# Access Compliance Report

## Public Rights-of-Way

### (Curb Ramps)

Intersection ID: 31398	Main Street: BRAWER_FARM_DR	Cross Street: GIBBON_RD	Location: S
ADA ID: A73737A468E2	Ramp Type: Perp	Initial Pass/Fail: Fail	Overall Compliance: No
		Severity Score: 10

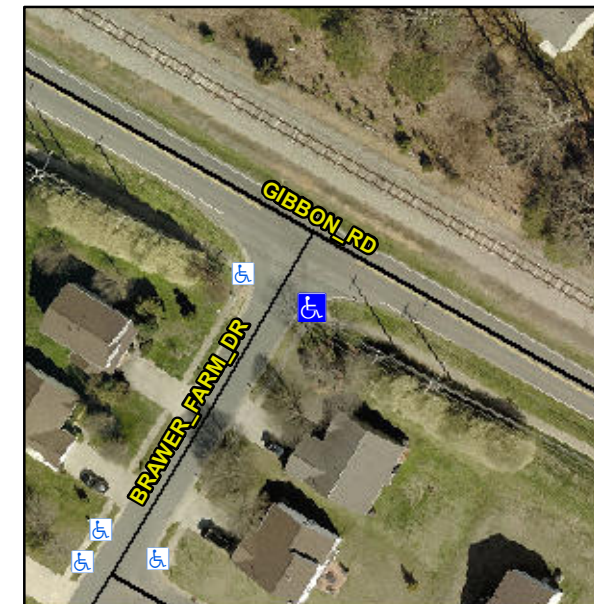
**Not Found, R304.5.1, R304.5.3**

Compliance	Description	Data	Compliance	Description	Data
N/A	Ramp Length (in)	51.0	Yes	Ramp Slope (%)	5.0
No	Ramp Width (in)	43.0	No	Ramp XSlope (%)	3.0
N/A	Flare Type LT	N/A	N/A	Flare Type RT	N/A
N/A	Flare Slope LT (%)	N/A	N/A	Flare Slope RT (%)	N/A
N/A	Flare Traversable LT?	N/A	N/A	Flare Traversable RT?	N/A
N/A	Landing Length (in)	N/A	N/A	DWS Provided?	N/A
N/A	Landing Width (in)	N/A	N/A	DWS Contrast?	N/A
N/A	Landing Slope (%)	N/A	N/A	DWS Length (in)	N/A
N/A	Landing X Slope (%)	N/A	N/A	DWS Full Width?	N/A
N/A	Landing Curb? (Y/N)	N/A	N/A	DWS Offset (in)	N/A
N/A	Shared Landing?	N/A			
N/A	Gutter Ponding?	N/A	N/A	Gutter Slope (%)	N/A
N/A	Gutter Lip Ht (in)	0.5	N/A	Gutter X Slope (%)	N/A
N/A	Painted X Walk1?	No	N/A	Painted X Walk2?	N/A
	X Walk 1 Direction	To W		X Walk 2 Direction	N/A
N/A	X Walk 1 Width (in)	N/A	N/A	X Walk 2 Width (in)	N/A
	X Walk 1 Slope (%)	0.8		X Walk 2 Slope (%)	N/A
	X Walk 1 X Slope (%)	4.3		X Walk 2 X Slope (%)	N/A

**Remove & Replace Entire Ramp.**
